City of Keene, New Hampshire
Historic District Commission

AGENDA - REVISED

STAFF REPORT

COA-2014-06, Modification #1 – 166 West St – Friendly’s Renovations & New Apartment Building

Figure 4. The existing and proposed north elevations for the former Friendly's restaurant located at 166 West Street.

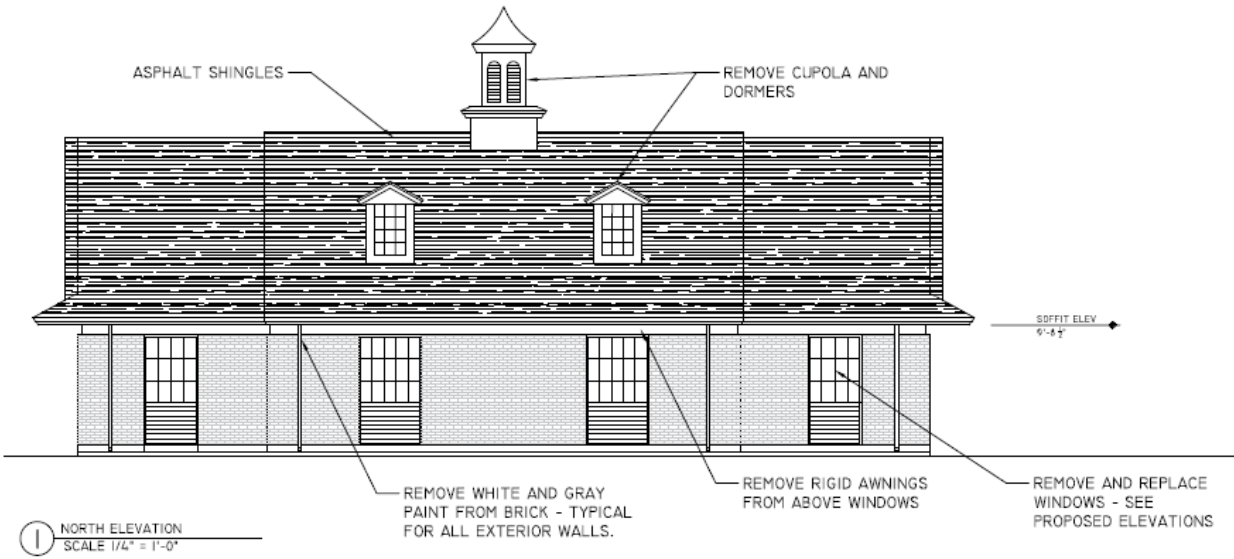
The Applicant proposes to renovate the exterior of the former Friendly's restaurant. Proposed changes include:

- Relocating the main entrance further to south along the eastern building façade to create a new entry portico supported by brick columns,
- Removal of the existing cupola, blind dormers, window awnings, and entry pediment,
- Removal of the white and gray paint from the brick masonry (discussed under Masonry, below),
- Replacement of the vinyl siding on the main gables with CorTen vertical steel siding,
- Installation of a dark gray standing seam metal roof on the northern portion of the roof,
- Replacement of the existing shingle roof with new architectural shingles in a dark gray color,
- Replacement of the existing windows with aluminum windows with a black finish and changing the number and configuration of windows, and
- Replacement of the existing egress doors, which will match the proposed aluminum window units.

These proposed changes are not based on physical, pictorial or documentary evidence as this building is not historic. Many of these changes are proposed in order to change the appearance of the building from Friendly's commercial aesthetic to that of an office building. All of the proposed materials are in keeping with materials that are common in the district, and are considered acceptable materials. See Figures 4-7 for a comparison of the existing and proposed elevations of the Friendly's building. This standard appears to be met.

Figure 7. The existing and proposed west elevations for the former Friendly's restaurant located at 166 West Street.

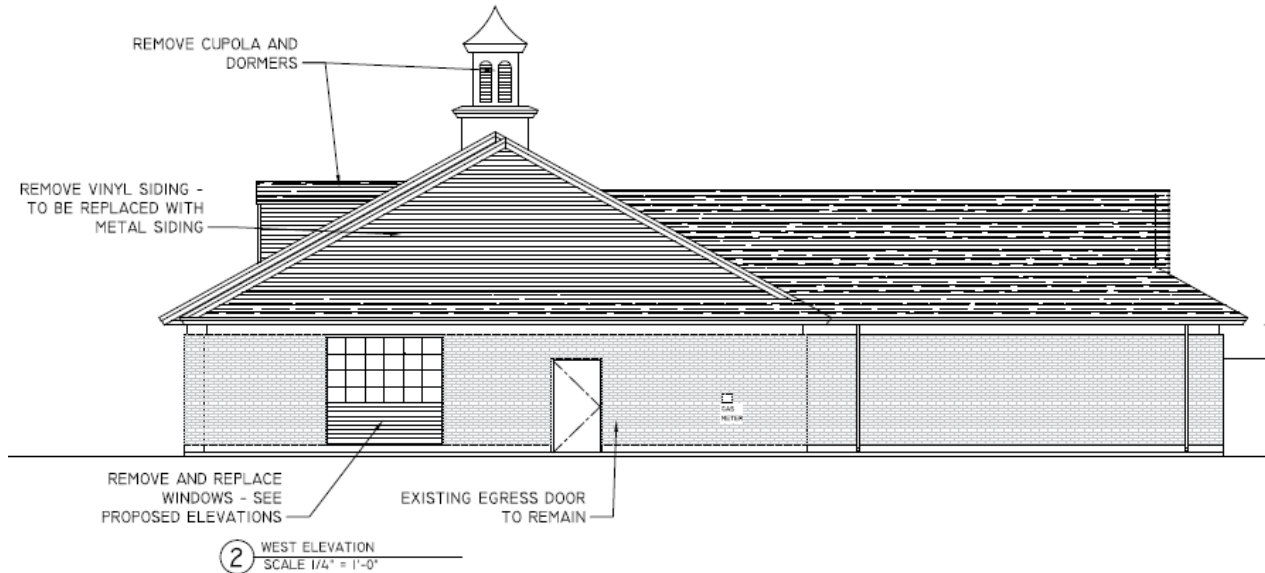
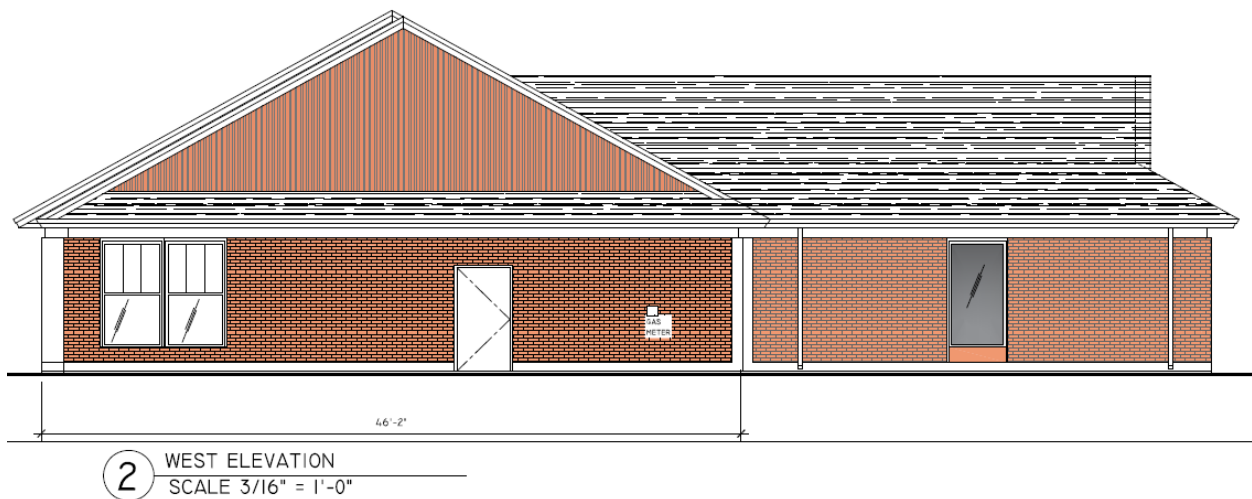
The Applicant proposes to remove the white and gray paint from the former Friendly's building by sandblasting the existing masonry. Section XV.C.2.a.3 of the HDC Regulations prohibits the cleaning of masonry with abrasive methods. The Applicant has submitted a waiver request to allow for sandblasting to be used, which is attached to this staff report. In the waiver request, the Applicant notes that he believes

If the Board is inclined to grant this waiver request, staff recommend that staff approval of a test patch of sandblasted masonry prior to paint removal be included as a condition of approval.

Figure 8. The proposed southern building façade for the new mixed-use building, which will be visible from Gilbo Avenue.

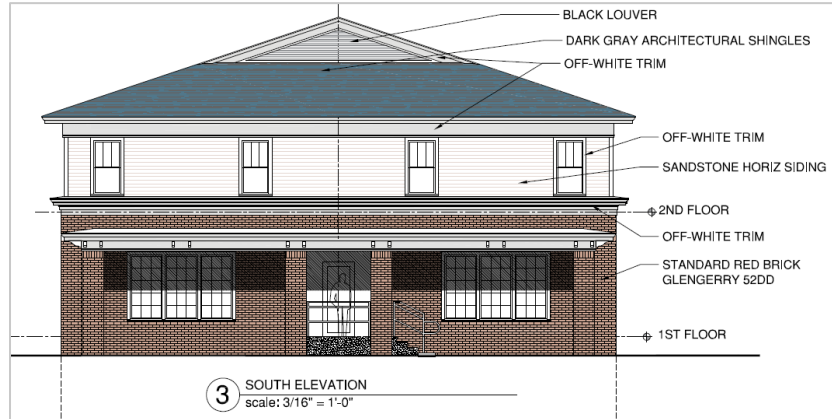
The building is proposed to be two stories, which is the minimum height requirement for this overlay district. Although the primary entrance will face the parking area to the east, there will be a secondary entrance on southern building façade that is accessible from Gilbo Avenue.

The proposed building will have a southern façade measuring approximately 52 feet long with a pedestrian-scale entryway, which will be accessible from a walkway that the Applicant proposes to install along the south building façade. This façade will be articulated by a grouping of three windows on each side of the

entryway on the first floor and four evenly spaced windows on the second floor. The Applicant proposes a cornice made of aluminum-wrapped wood in an off-white color to separate these two floors.
